# 1971 Corvette: Service Bulletin: Anti-Diesel Relay

**Subject:** Anti-Diesel Relay

**Bulletin No:** 71-T-44

**Date:** Aug. 5, 1971

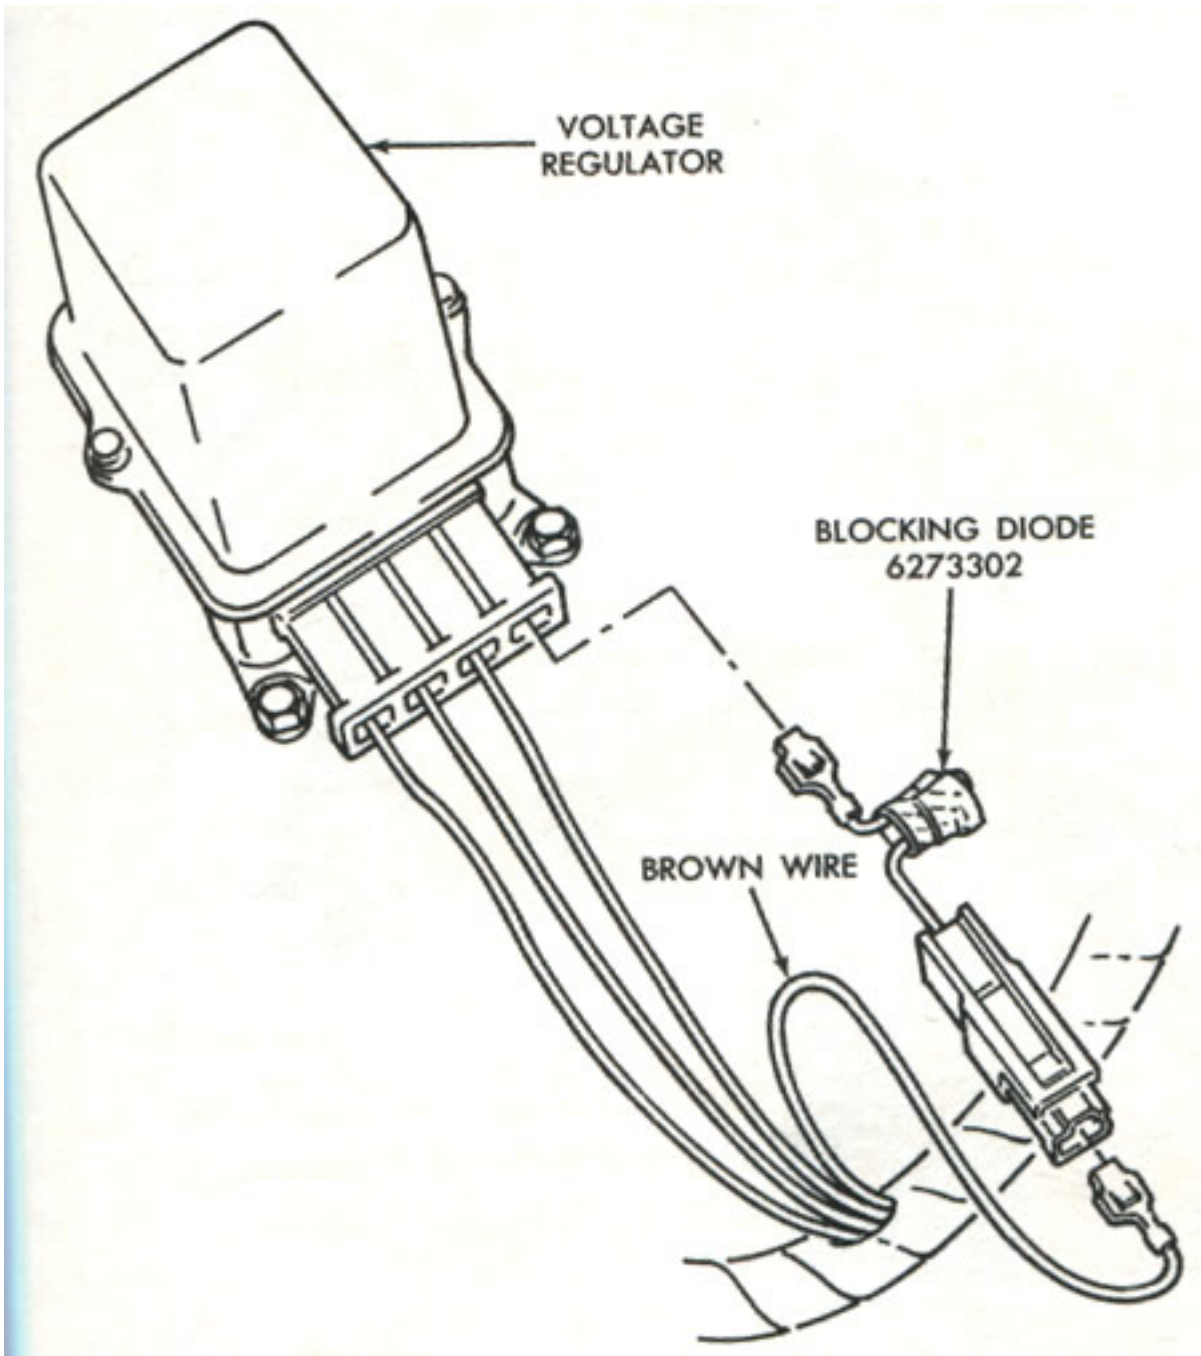
Delcotron feedback at the anti-diesel relay can result in a shorted transistor in the timing circuit of the relay. A shorted transistor will cause the anti-diesel relay to hold the air conditioning compressor clutch engaged continuously, after the engine is turned off, draining the battery.

A new anti-diesel relay, with a suppression diode across the relay coil to protect the transistor, entered production the week of April 26, 1971, at all assembly plants. Also, a blocking diode is being installed at the voltage regulator to prevent Delcotron feedback on all models except Corvette. The Corvette uses the new relay but, due to the integrated regulator, does not require the voltage regulator blocking diode.

For service on light trucks, to prevent Delcotron feedback to the anti-diesel relay, blocking diode, Part Number 6273302, should be installed at the voltage regulator as outlined under Service Procedure - Truck.

Blocking Diode Installation

1. Disconnect wiring harness from voltage regulator.
2. Remove brown wire from the plastic connector.
3. Install the blocking diode between the voltage regulator connector and the brown wire as illustrated in Figure 1.
4. Connect harness to voltage regulator.
